[Docket No. FAA-2006-25097; Directorate Identifier 2005-SW-19-AD; Amendment 39-14762; AD 2006-19-05]

Airworthiness Directives; Arrow Falcon Exporters, Inc. (Previously Utah State University); Firefly Aviation Helicopter Services (Previously Erickson Air-Crane Co.); California Department of Forestry; Garlick Helicopters, Inc.; Global Helicopter Technology, Inc.; Hagglund Helicopters, LLC (Previously Western International Aviation, Inc.); International Helicopters, Inc.; Precision Helicopters, LLC; Robinson Air Crane, Inc.; San Joaquin Helicopters (Previously Hawkins and Powers Aviation, Inc.) S.M.&T. Aircraft (Previously U.S. Helicopters, Inc., UNC Helicopter, Inc., Southern Aero Corporation, and Wilco Aviation); Smith Helicopters; Southern Helicopter, Inc.; Southwest Florida Aviation International, Inc. (Previously Jamie R. Hill and Southwest Florida Aviation); Tamarack Helicopters, Inc. (Previously Ranger Helicopter Services, Inc.); U.S. Helicopter, Inc. (Previously UNC Helicopter, Inc.); West Coast Fabrication; and Williams Helicopter Corporation (Previously Scott Paper Co.) Model HH-1K, TH-1F, TH-1L, UH-1A, UH-1B, UH-1E, UH-1F, UH-1H, UH-1L, and UH-1P Helicopters; and Southwest

FIGURE 1

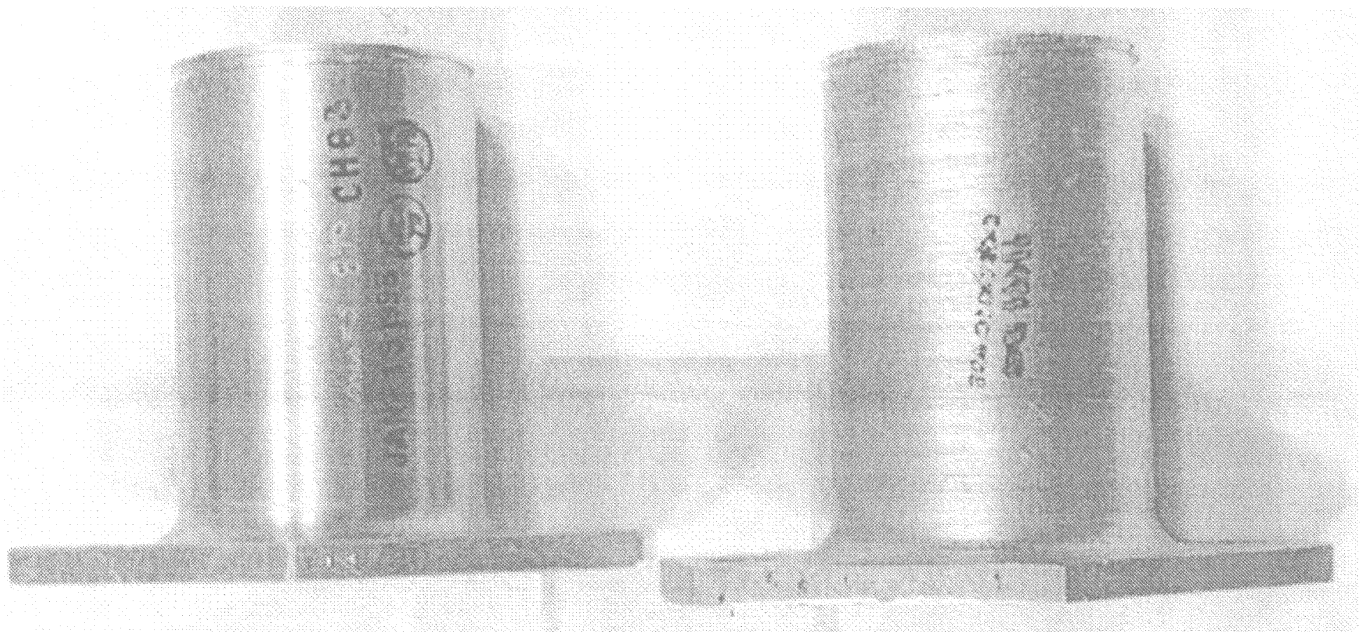
Note 1: T/R sliders manufactured by Forest Scientific, Inc., were produced under a military contract and do not meet the OEM specifications. The machining process resulted in excess surface roughness. See Figure 1 of this AD.

Tail rotor sliders manufactured by Bell Helicopter Textron, Inc. (left) and Forest Scientific, Inc. (right). Note the rough finish of the Forest Scientific, Inc.-manufactured T/R slider compared to the one shown on the left.

(iii) On or before accumulating 1000 hours TIS or on or before 12 months, whichever occurs first, replace each T/R slider that has an illegible CAGE code or Code 15716 or 26098 with an FAA approved airworthy slider without a CAGE code or with a legible CAGE code other than 15716 or 26098. Any T/R slider removed from service based on the requirements of this paragraph is not eligible for installation on any helicopter.
